Plan Review Resubmittal

Re: 905 North Avenue
Building Permit #: COM-2307306
Address: 905 North Avenue

OFF-SITE IMPROVEMENT PLANS FOR
NERRADSCALI SUBDIVISION
SACRAMENTO, CA 95838
APN: 237-0200-092

DRAINAGE STUDY AND STORM WATER QUALITY CONTROL PLAN

4 NTS MANHOLE DETAIL

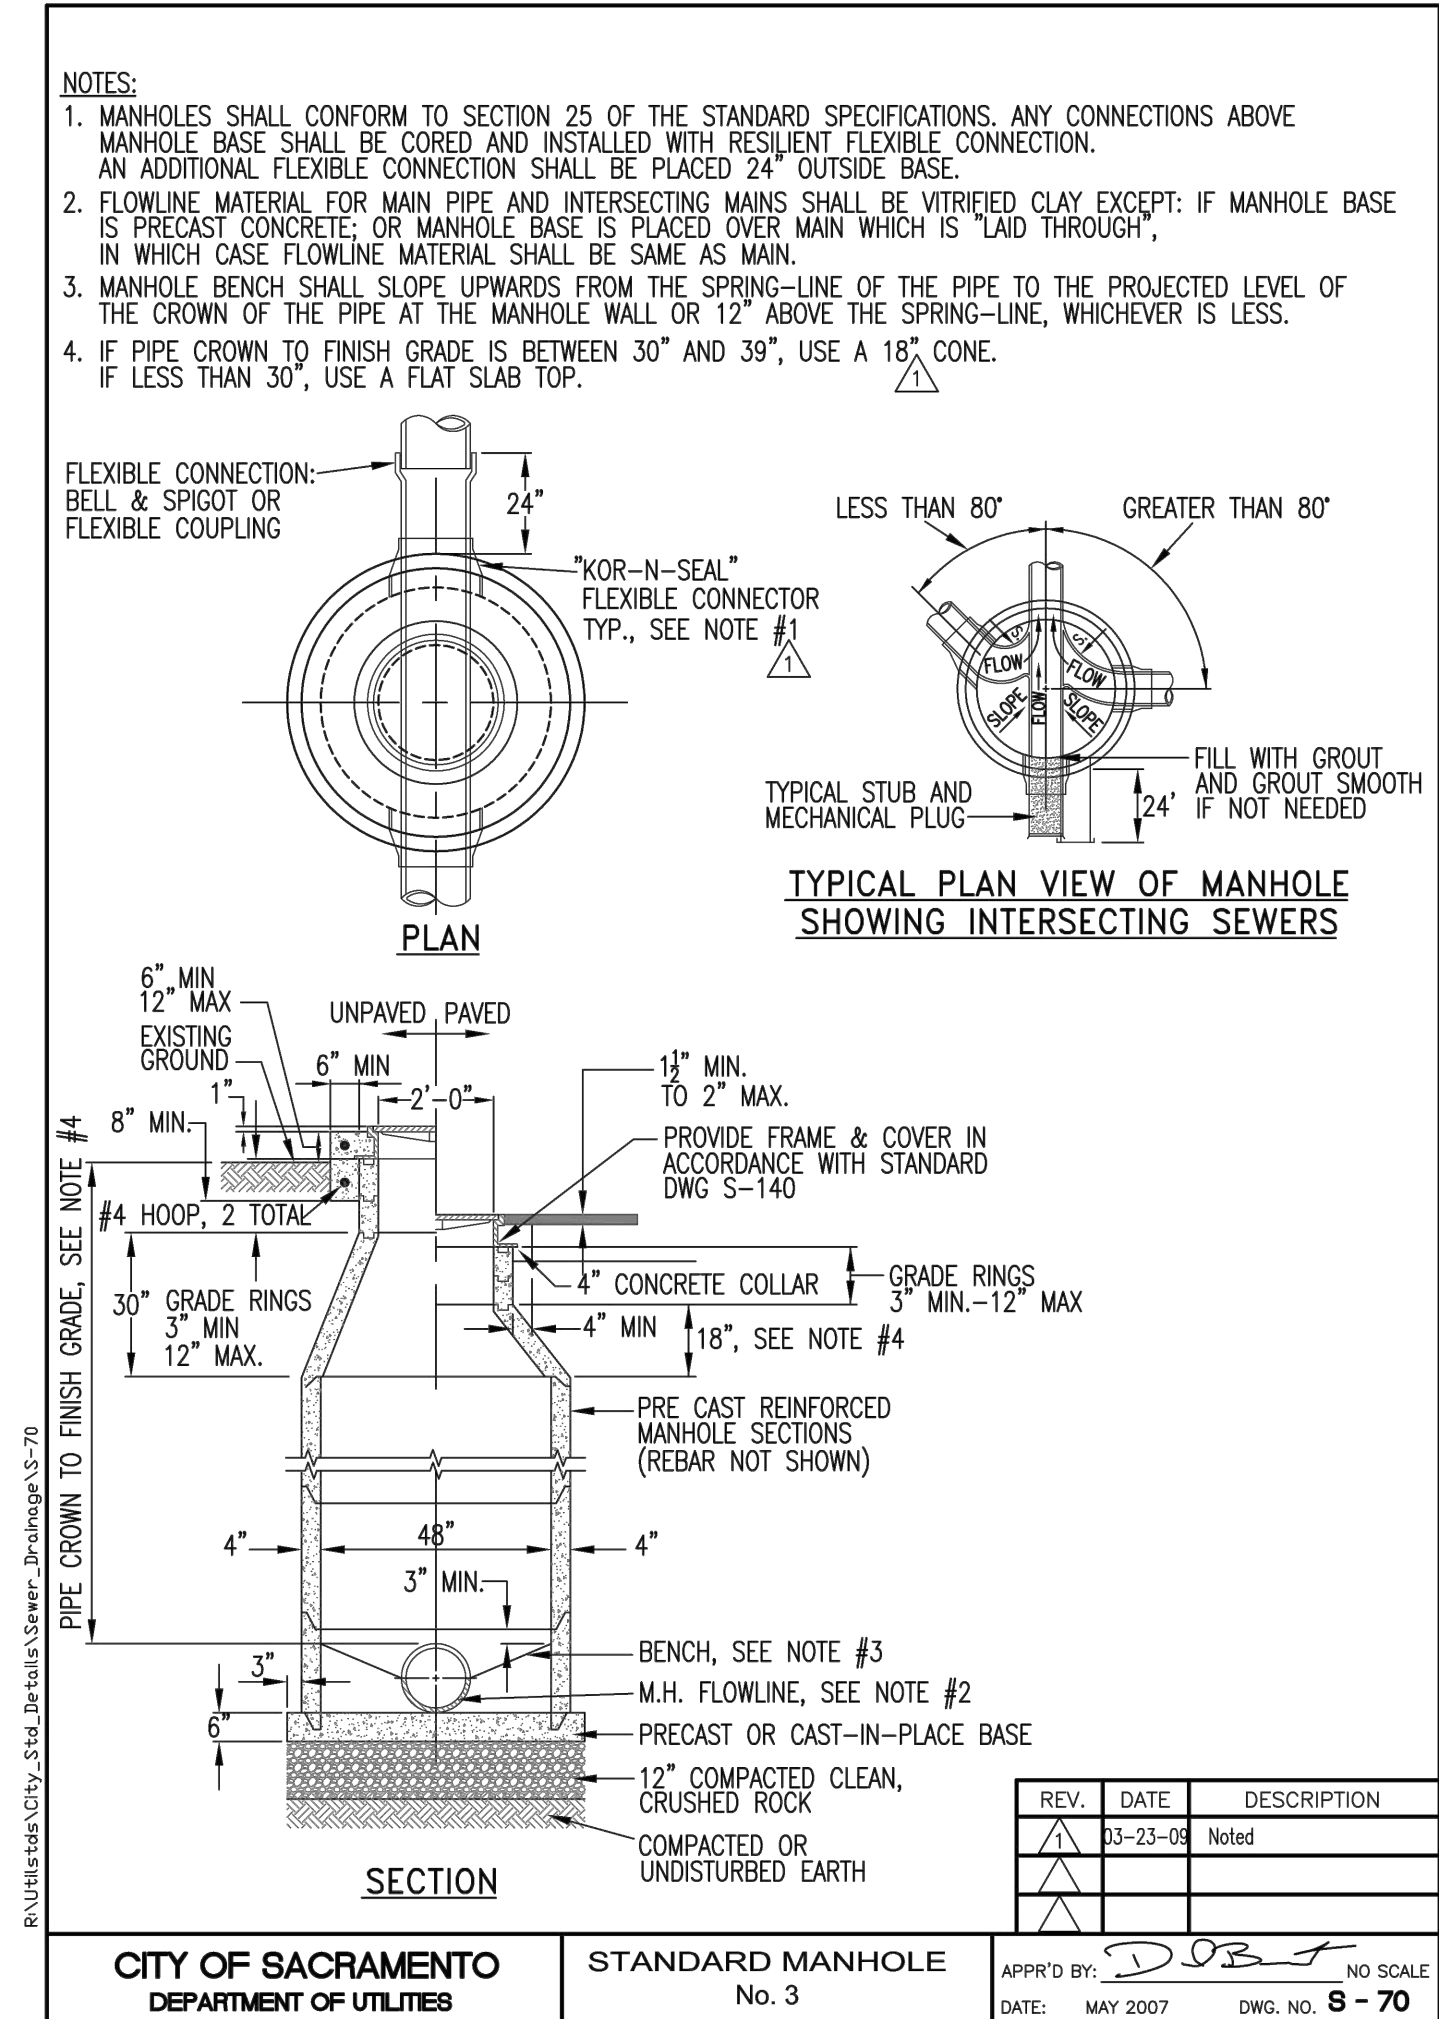
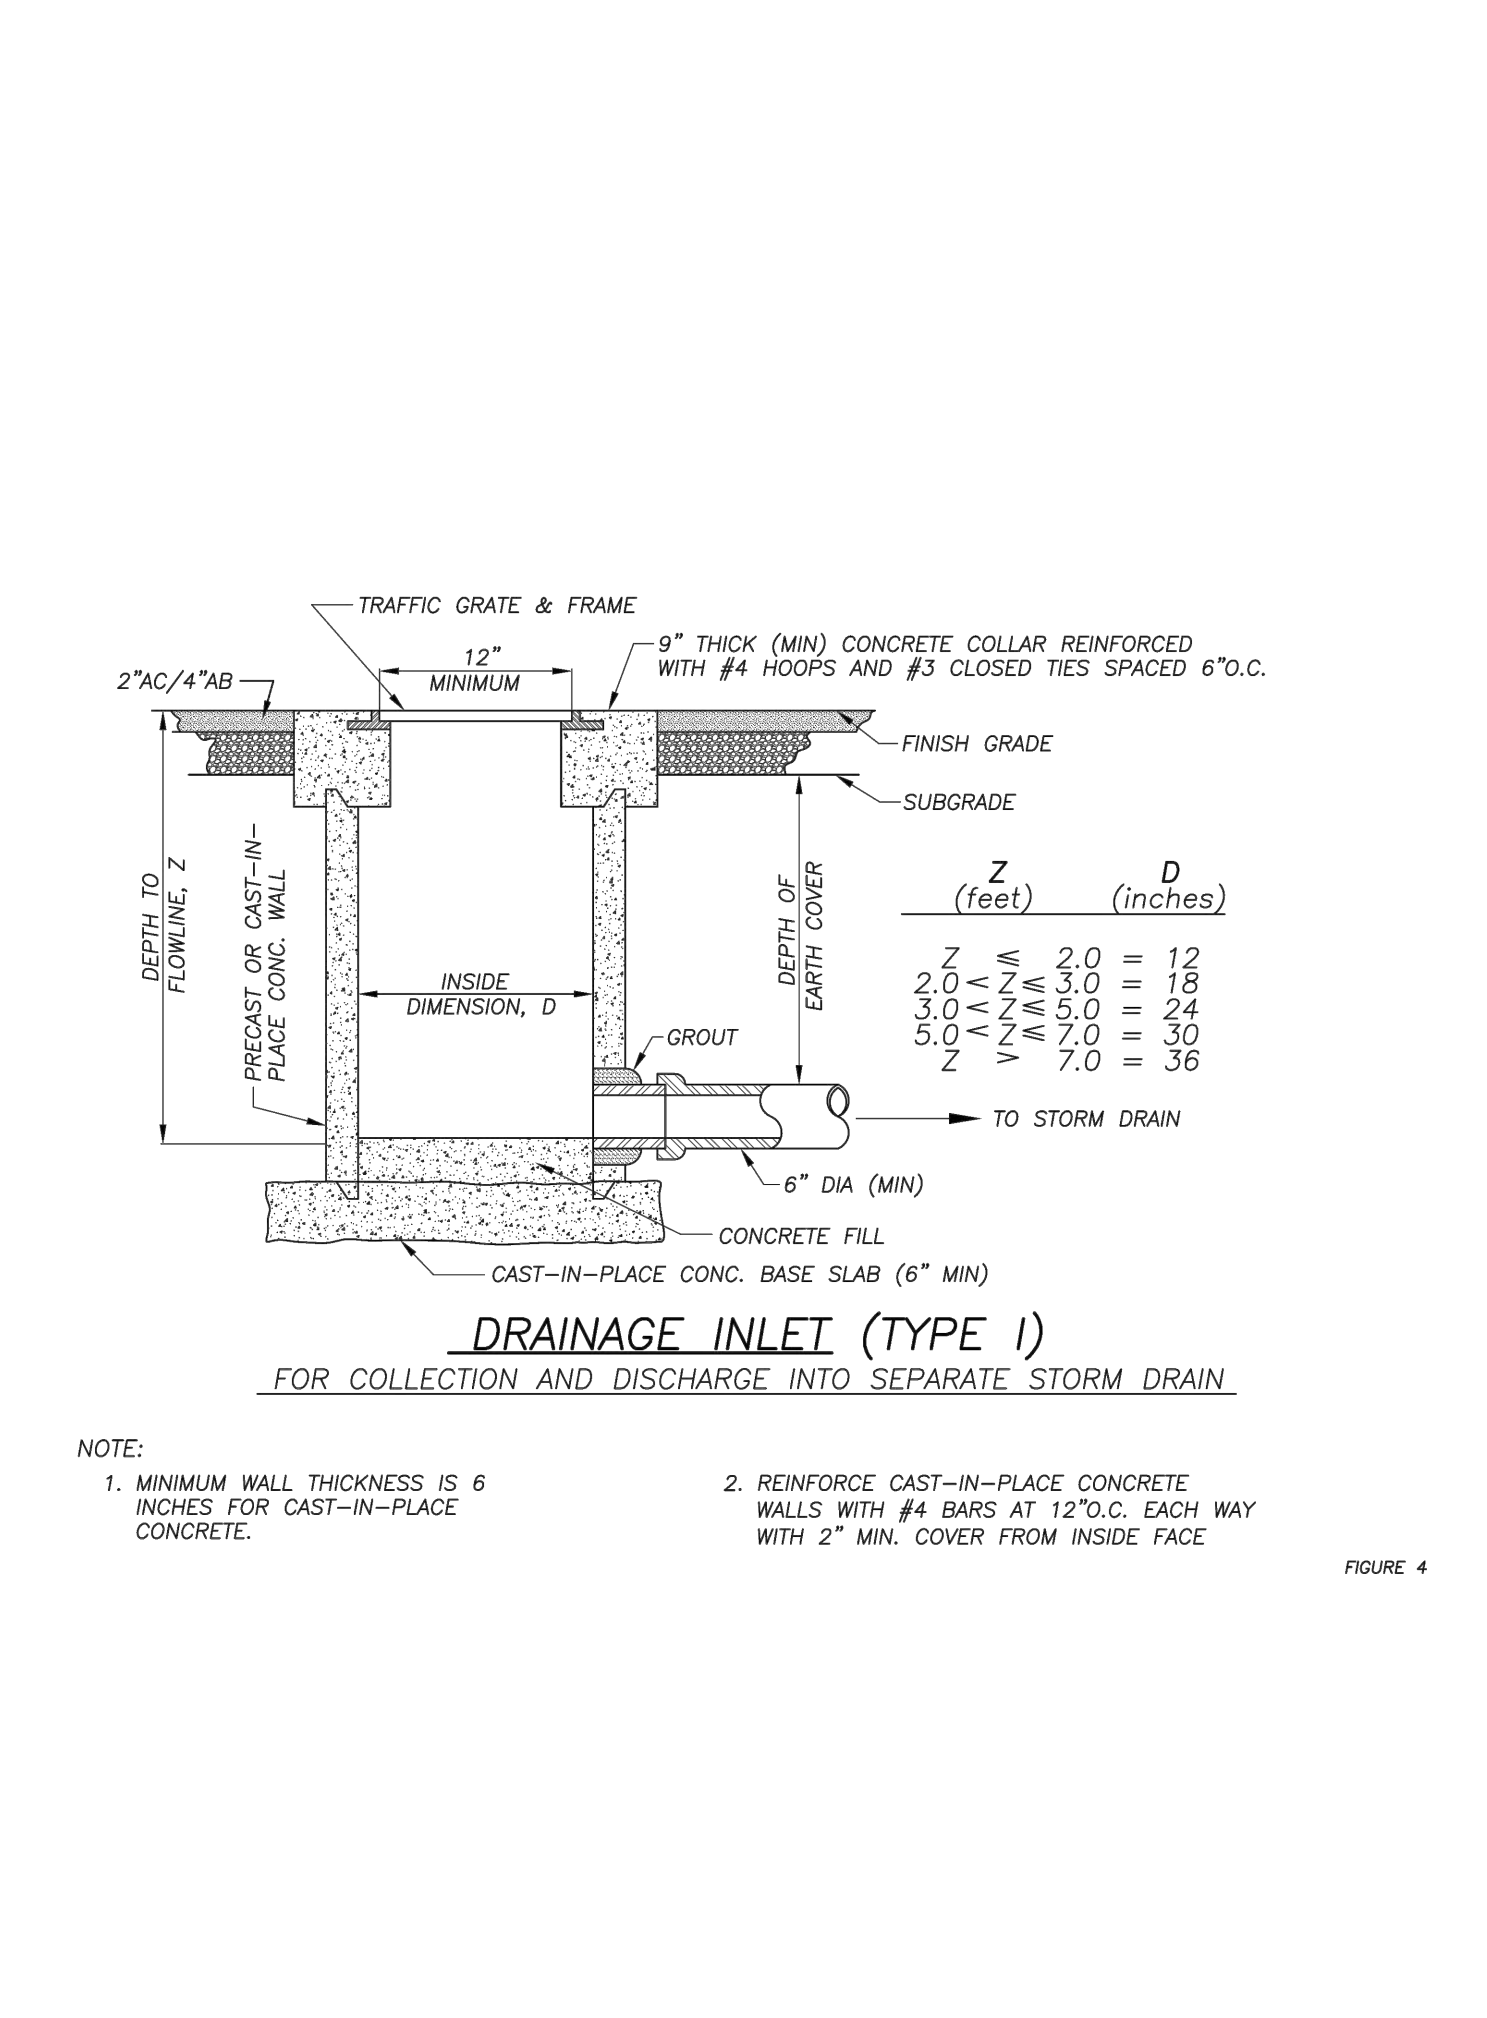
Use standard manhole 3A per City Standard Drawing S-80, when greater than 8-feet deep and less the 27" diameter.

Revised to Standard Drawing S-80. Detail 4 on sheet C10.2 also updated.

WATER CALCULATIONS AND EPANET REPORT

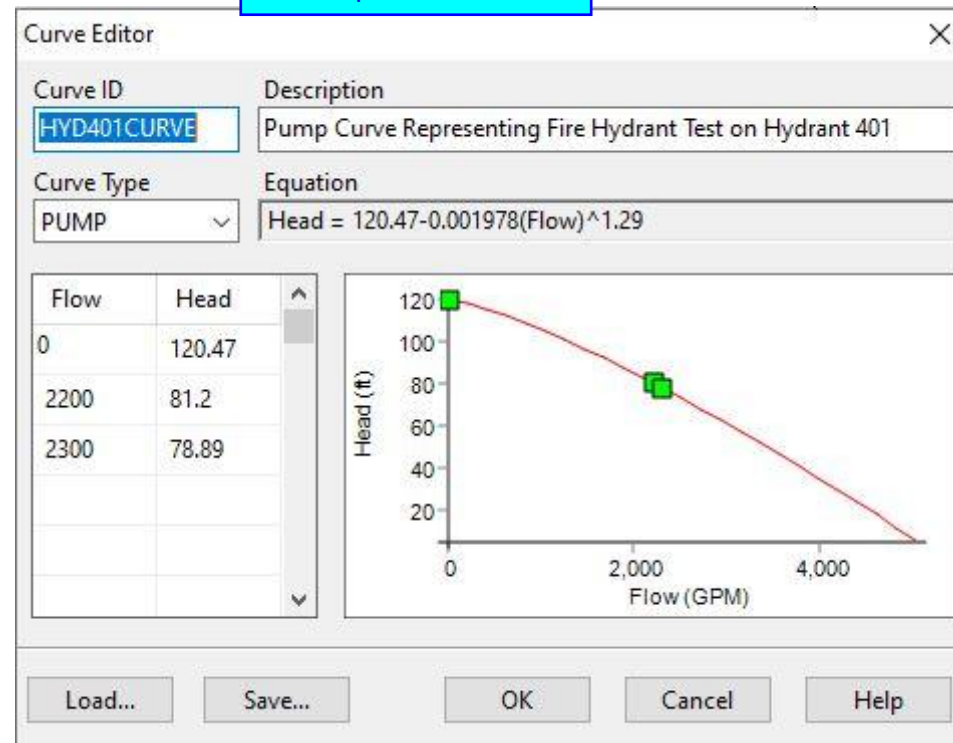
update curve per latest
water supply test.

Curve updated
